RE: Marriott Springhill Suites Development at 109 Marbledale Road

REVISED Comments on the planned remediation and development of the *Former Marble Quarry Landfill Site*

September 14, 2016

Prepared on behalf of the Marbledale Road Environmental Coalition

Figure 1. Dynamic compaction.

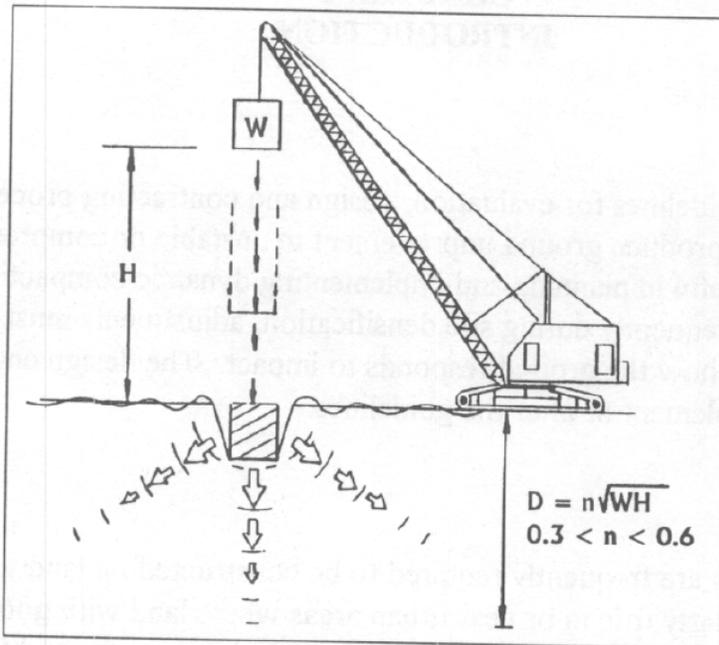
The use of this technology creates tremendous risks that make it unsuitable for use a hazardous waste site like the *Former Marble Quarry Landfill Site*. These risks include:

1. Each time the weight is dropped on the ground, significant amounts of dust are created which would be difficult to control since it is explosively ejected into the air. Dust particles at this site will include fine ash which tends to have the highest concentrations of heavy metals, polycyclic hydrocarbons, and very possibly dioxins. These particles pose the greatest risks to children and the elderly in the community.

2. DDC generates strong vibrations which could easily disrupt buried drums and tanks at the site. We already know that buried equipment and/or tanks are leaking Freon vapors. DDC could be disastrous at the site, turning slowly leaking containers into major leaks, or even small explosions as corroded tanks suddenly fail.

Moreover, the DDC method generates significant low-frequency vibrations. According to CS&A, “Based on our experience and the site conditions, we expect that the DDC program can be designed in a manner that will not detrimentally affect the nearby structures. However, vibrations will be felt in the area surrounding the site. Because of the ground vibrations generated during DDC, the process must be closely monitored by a seismologist using a seismograph to ensure that...nearby structures are not adversely affected.” Use of DDC over the 3.5-acre site in a densely populated area is sure to generate a lot of complaints from local residents.

Moreover, I urge the Planning Board not to allow the use of dynamic soil compaction at this site, as this will almost certainly cause buried tanks and drums that are close to the surface to rupture.
